Unimas Sportswear Ltd (New Expansion Building)

Baghbari, Kashimpur, Gazipur
(23.955867, 90.313063)

31st January 2022

New Expansion Building: 11 storied (B+G+10) building with one basement floor.

Cylinder test for mat foundation & core test report for column

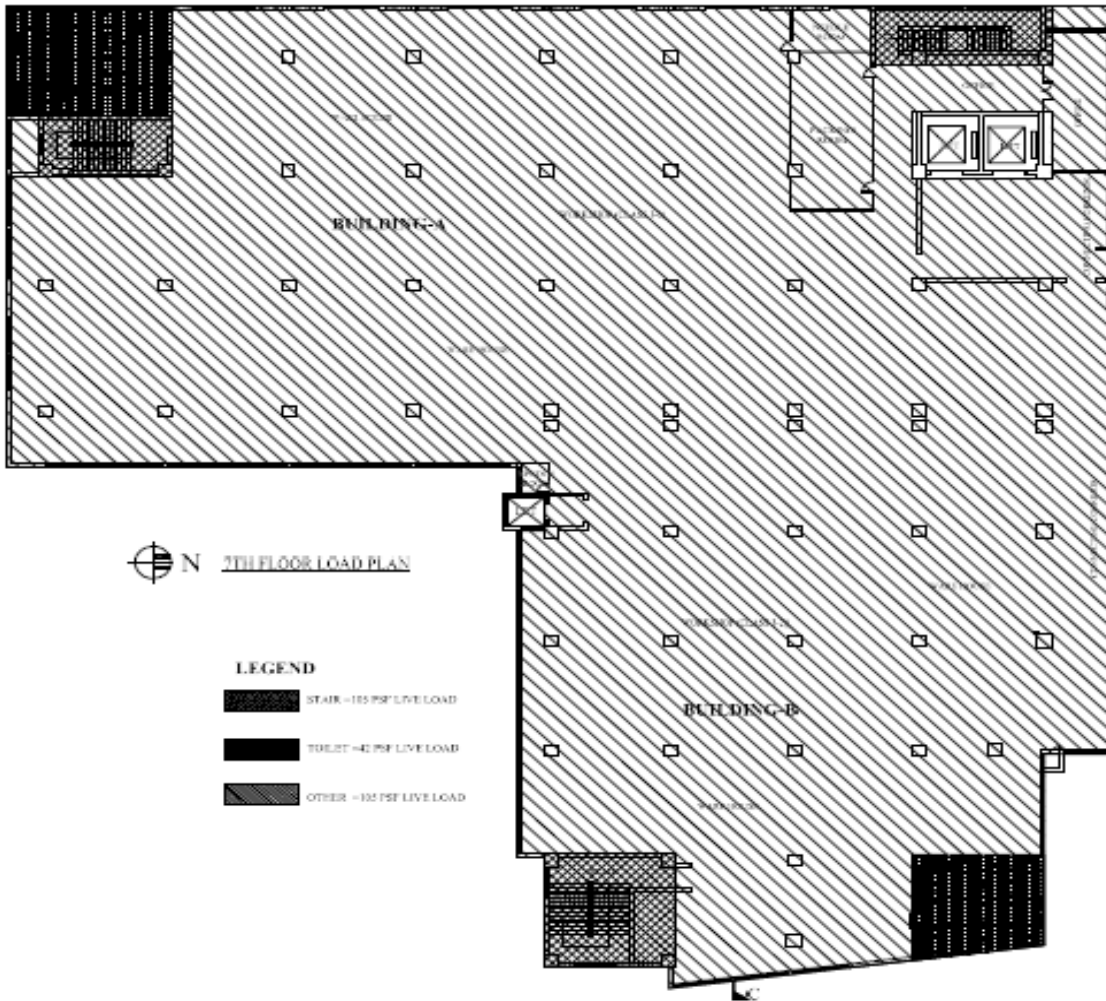
The factory has 38 sets of cylinder test report, among them 12 sets from column & 15 sets from beam/slab, 2 sets from mat foundation & rest doesn't have average value. The factory also has 8 sets of core test report for columns. In the DEA report factory have considered same concrete strength for mat foundation & column though mat foundation has separate sets of test report. Again, for column & floor 3 sets of concrete cylinder test has not been considered in the DEA. However, the building engineer is required to use concrete strength from core test report for columns and cylinder test report for other structural members.

10th floor layout plan

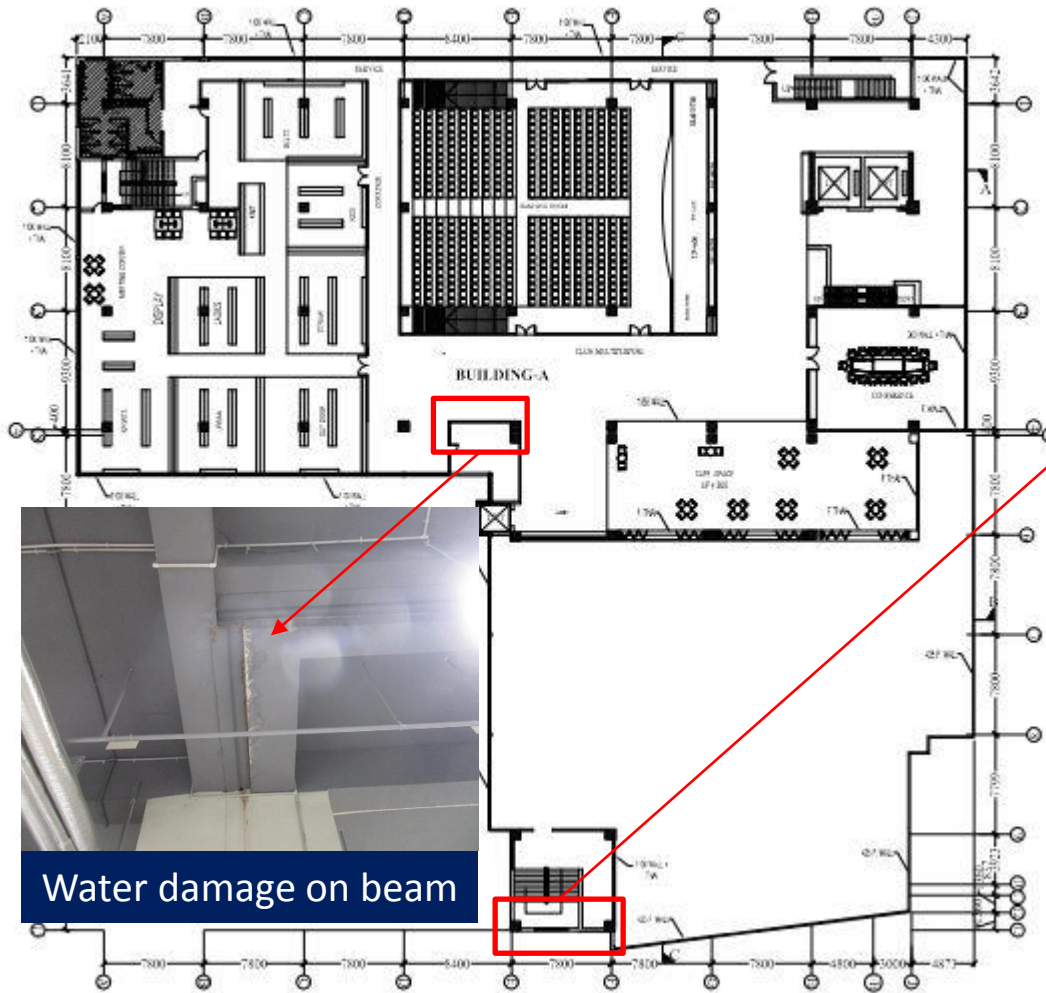
Water damage on beam & column

Water damage on beam

Water damage on beam & column

Stagnant of water and water damage observed on beam & column. Building engineer is required to check the extent of the damage and suggest suitable repair works.

1st floor layout plan

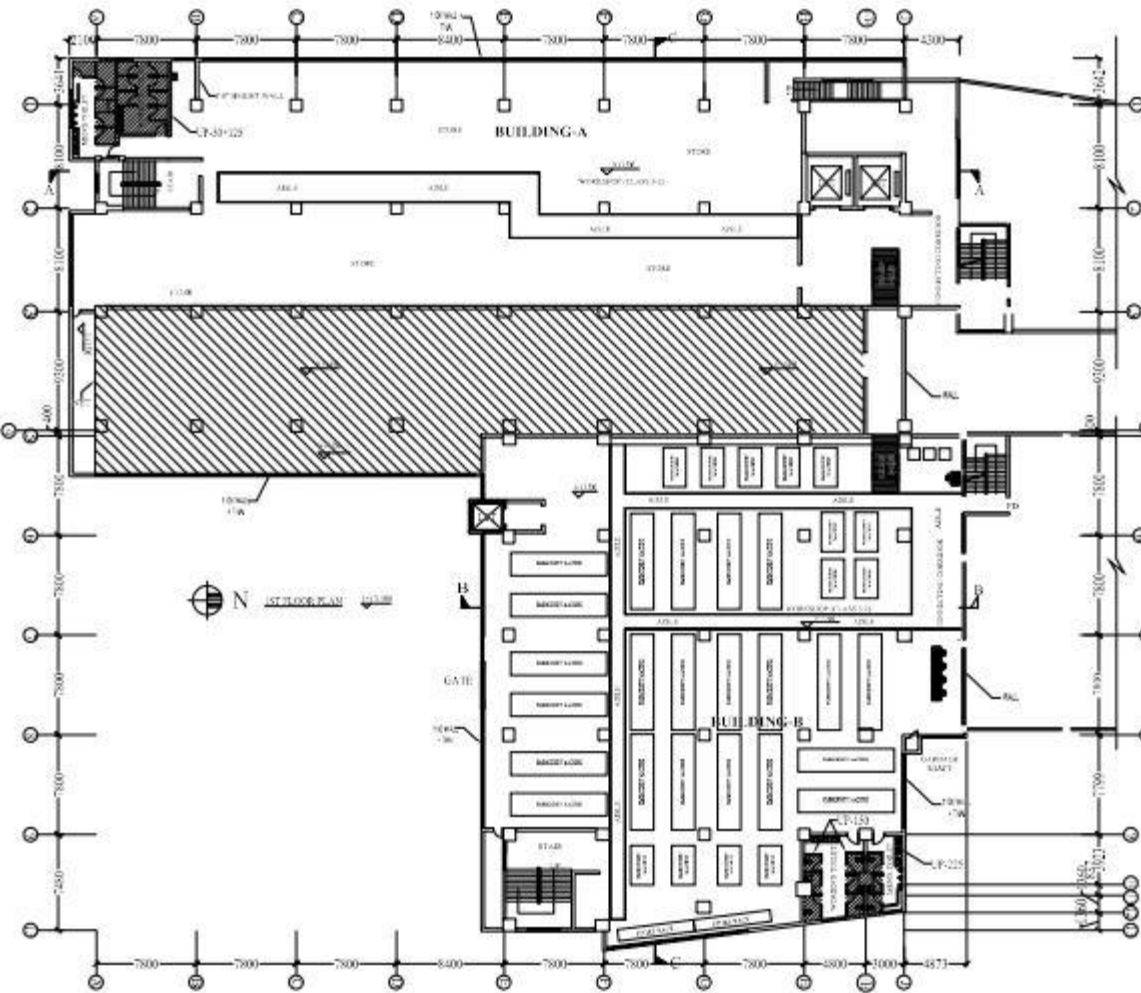
Vibration on floor

There are noticeable vibration on the 1st floor due to the operation of the embroidery machine. Building engineer is required to take necessary action to minimize the floor vibration.

Ground floor plan

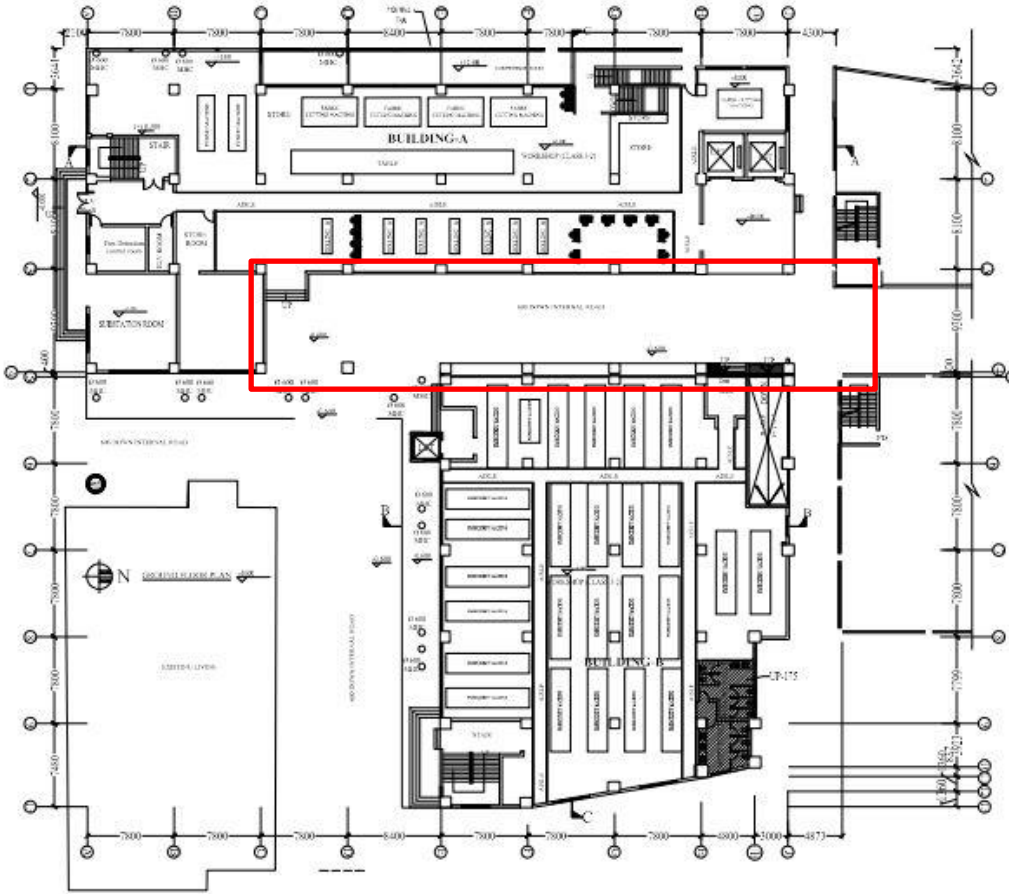
Ground floor column susceptible to vehicle impact

Basement column susceptible to trolley impact
